CITY OF WOODBURN
COMMUNITY DEVELOPMENT

MEMORANDUM

Date: October 5, 2020
To: Dago Garcia, P.E., City Engineer
Cc: Chris Kerr, AICP, Community Development Director
Roy Hankins, PE, Emerio Design
From: Colin Cortes, AICP, CNU-A, Senior Planner *cc*
Subject: **Planning Division review comments on 2nd submittal / 1st re-submittal
Sept. 18 of civil engineering plans for Smith Creek Development Ph. 3B**

SMITH CREEK PHASE 3B

CURB RETURN - SE CORNER OF KILLIAN AND DESANTIS 10
1" = 5'

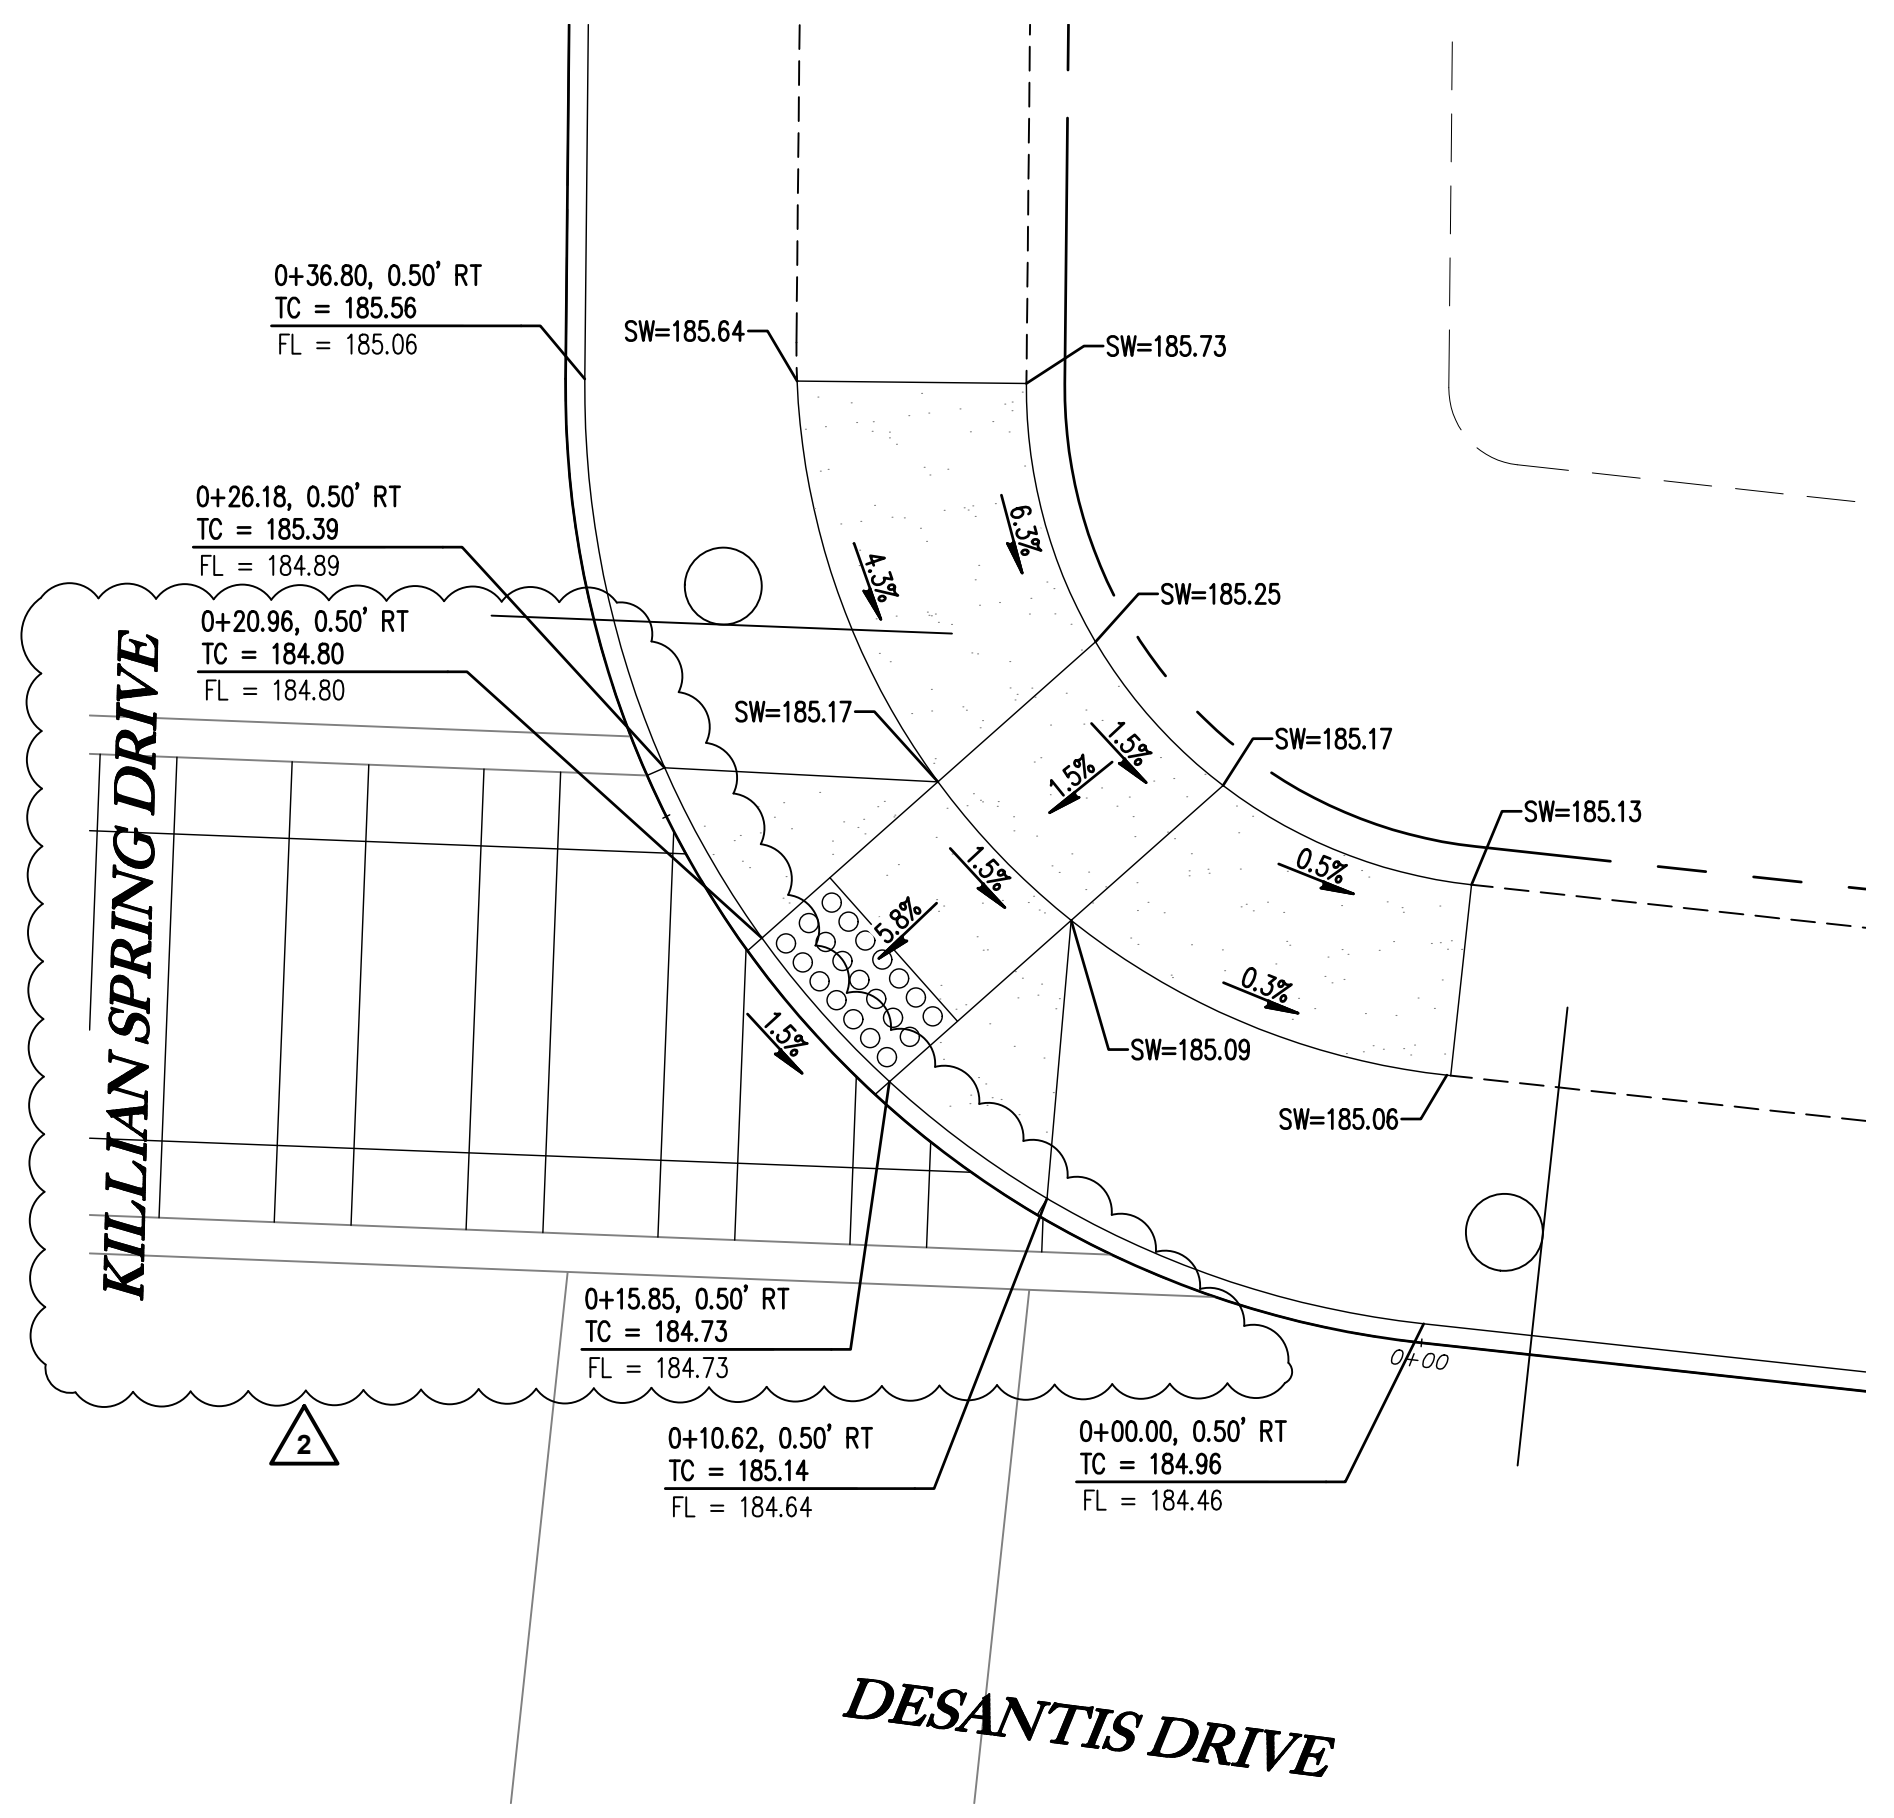
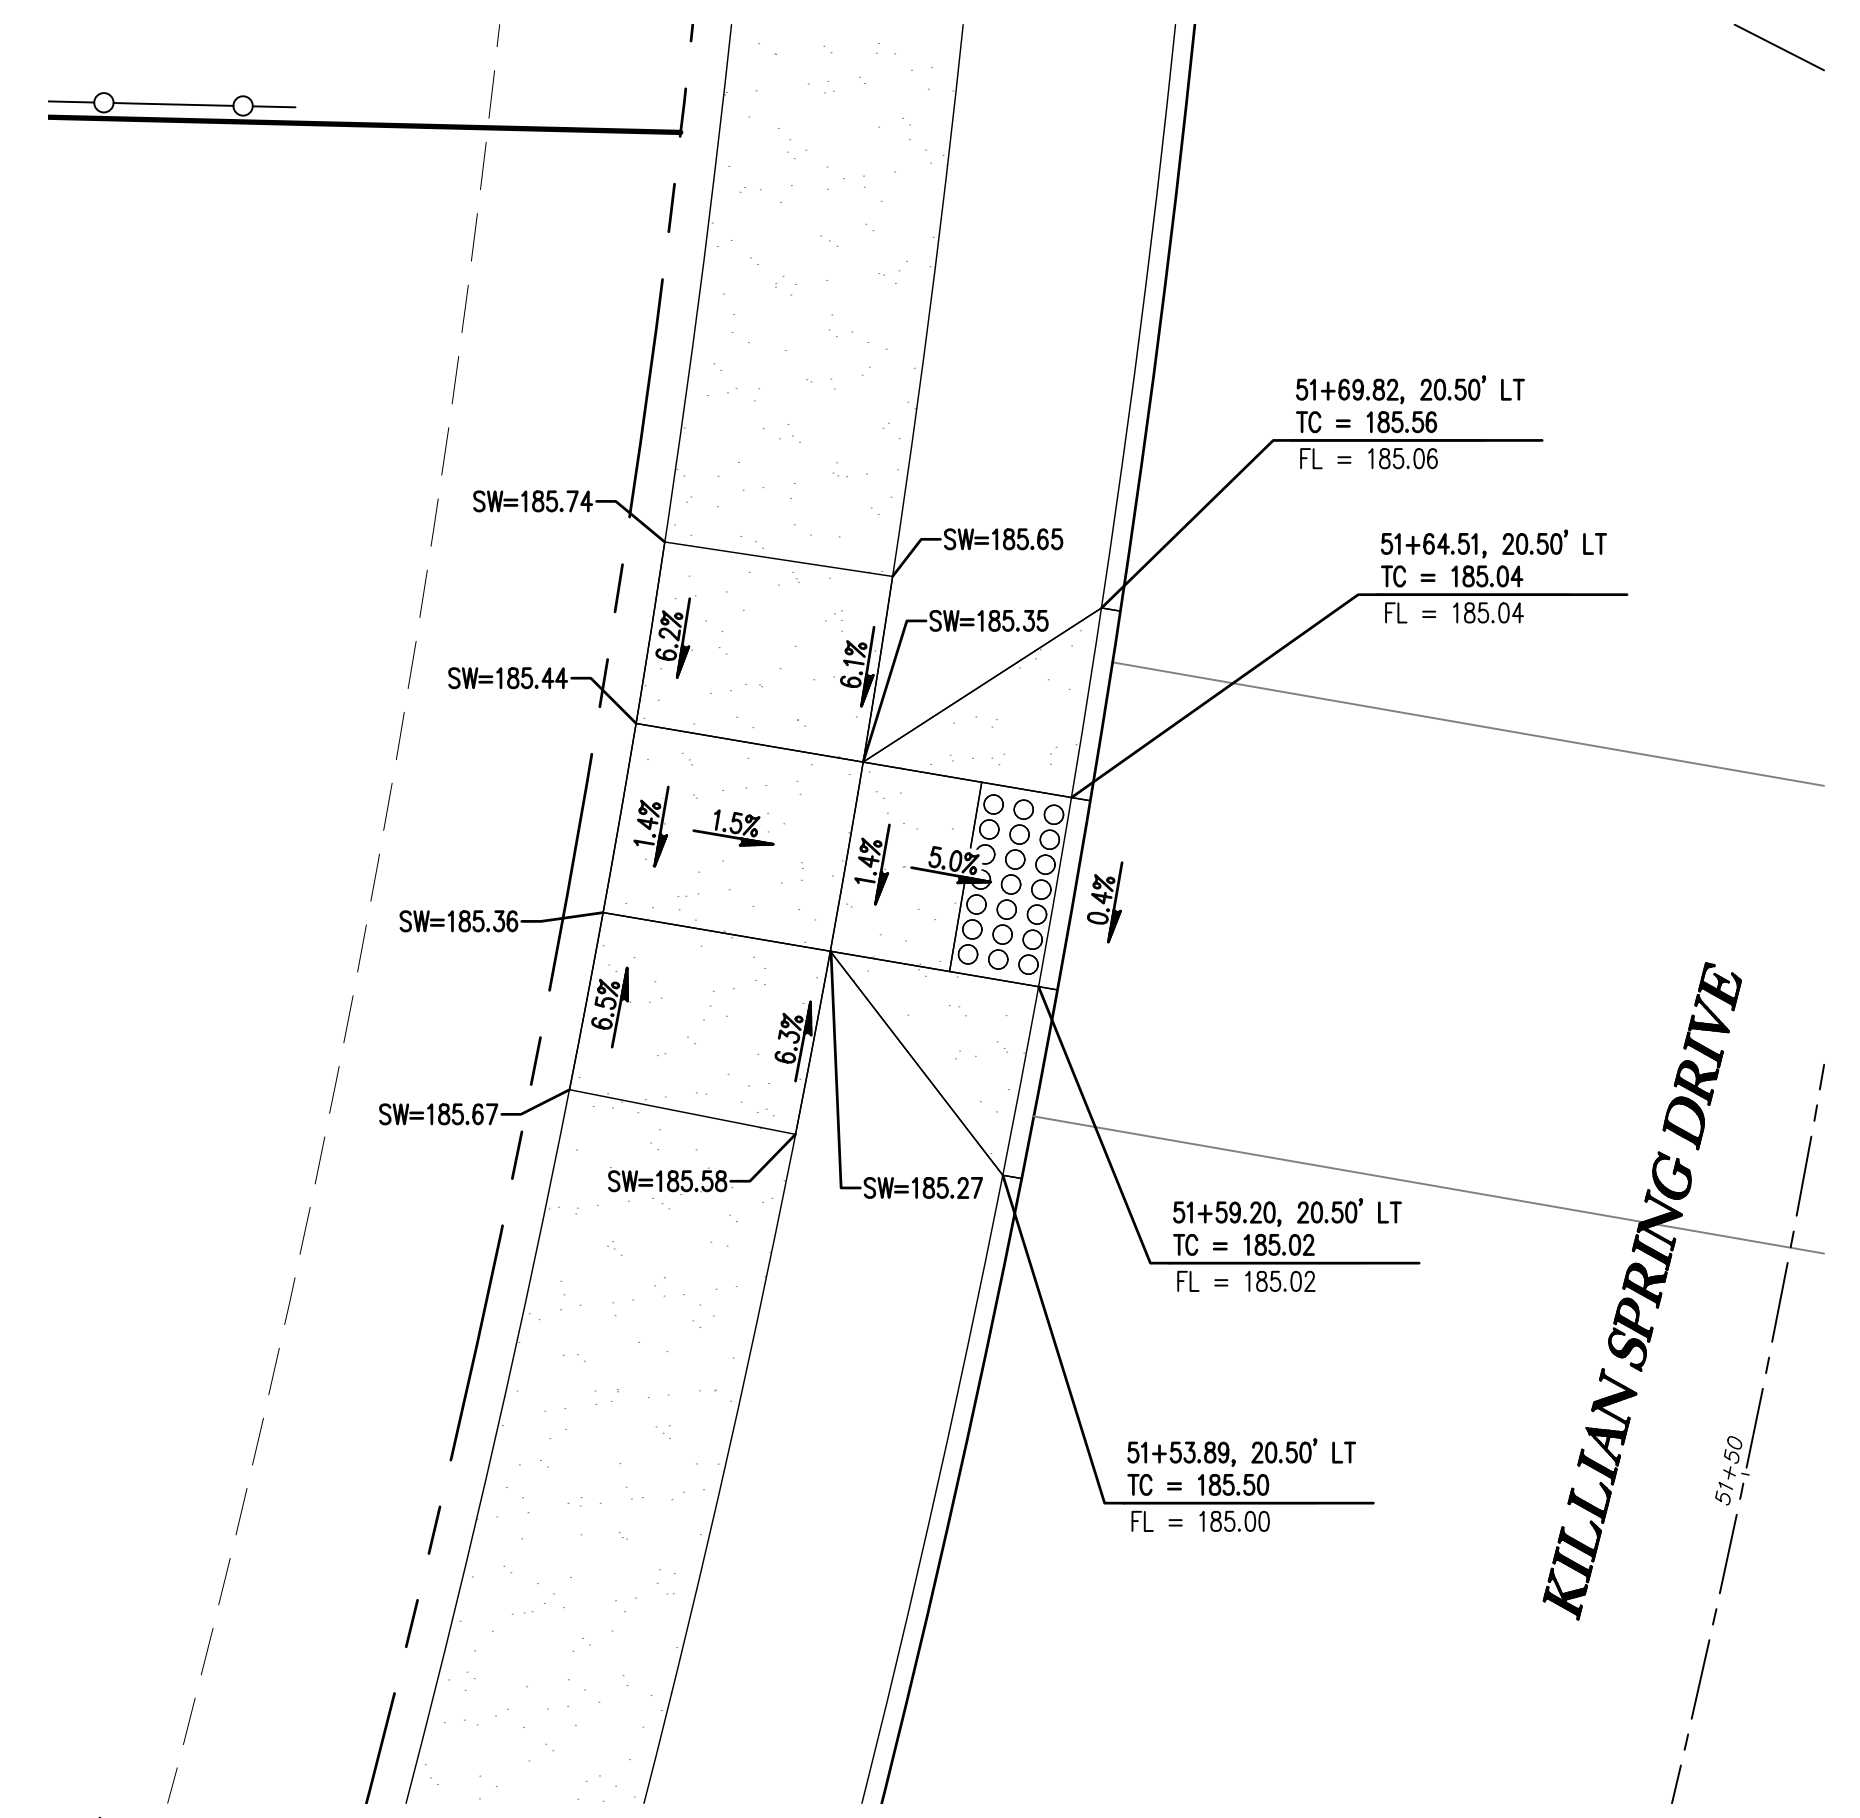
Sheet 3: Stamped concrete crosswalks typical section; and

Sheet 16: Curb return details 7, 9, 10, & 12:

The information is too vague to indicate pavement stamping/treatment, color, and pattern in conformance to the attached excerpted memo I'd sent Stafford Land Co. in August 2019 in response to a request to staff to direct on these topics when the issue first arose for Smith Creek through Phase 1A civil engineering plans.

Patterns: The pattern does not match any of the approved patterns. Thumbnail views of Attachment 1P are below:

Revise Sheets 3 & 16 accordingly.

SMITH CREEK - PHASE 3B
TAX MAP 052W13-TL 100
WOODBURN, OREGON

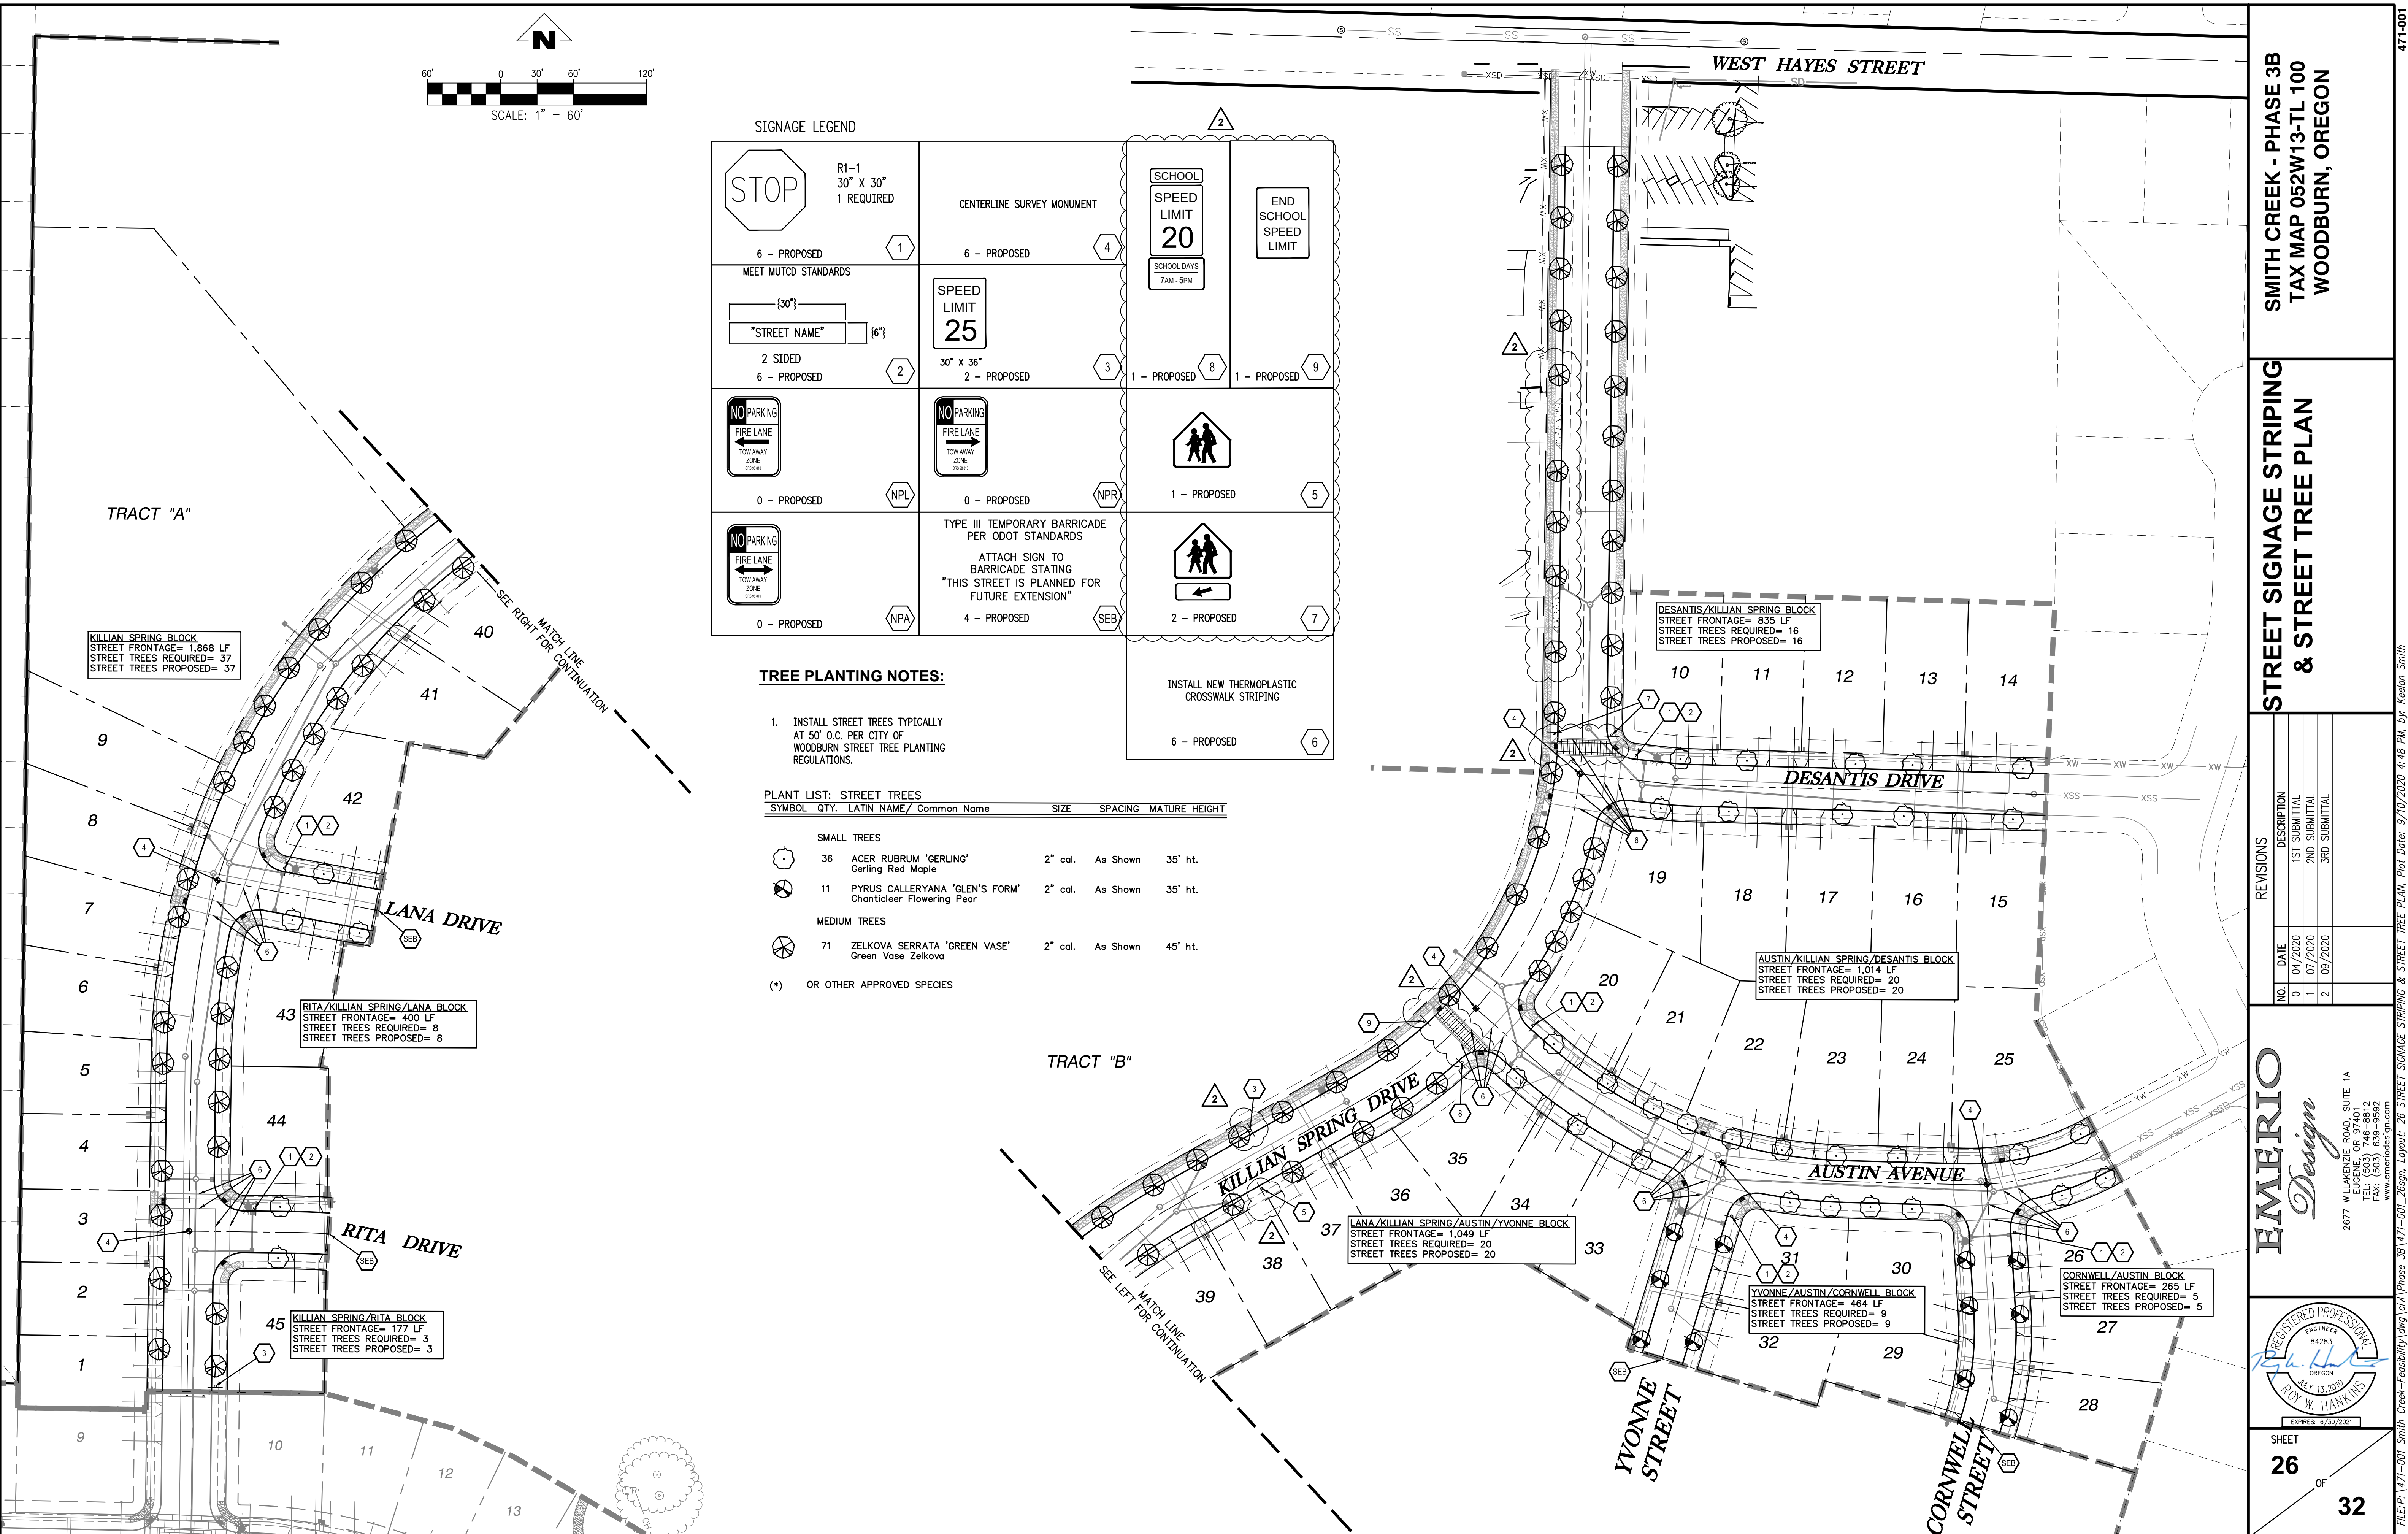
Revise Sheet 25 (street tree plan) to account for displacement by the south driveway of a tree or trees. (Note: There appears to be room to the north, and trees are permissible above vision clearance area if planted and pruned 7 ft above grade per [Woodburn Development Ordinance](#) 3.03.06C.1.)

Revise on Sheets 10 & 26 the driveway approach / apron / curb cut and dimension label to conform; staff recommends 24 ft, the same as is the south driveway.
